Access Compliance Report Public Rights-of-Way (Pedestrian Signals)

Main Street: FUTURA_DR Cross Street: FAIRMONT_BLV Location: SE

ADA ID: SGAT210921152200 Signal Type: One Push Button-Non APS Overall Compliance: No Severity Scores: BTN 1: 35 BTN 2: N/A No BTN: N/A

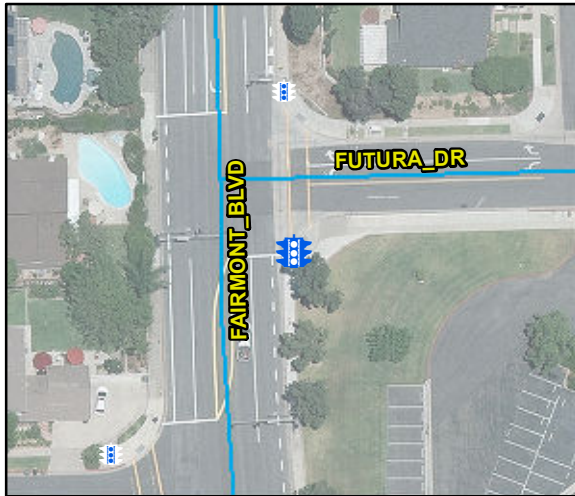
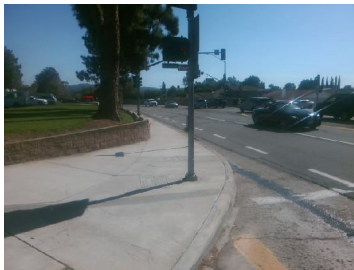
OC Std/PROW: R404.2, R404.3, MUTCD 4e.08

Possible Solutions: Replace Signal Push Button With APS Button. Remove and Replace Clear Space.
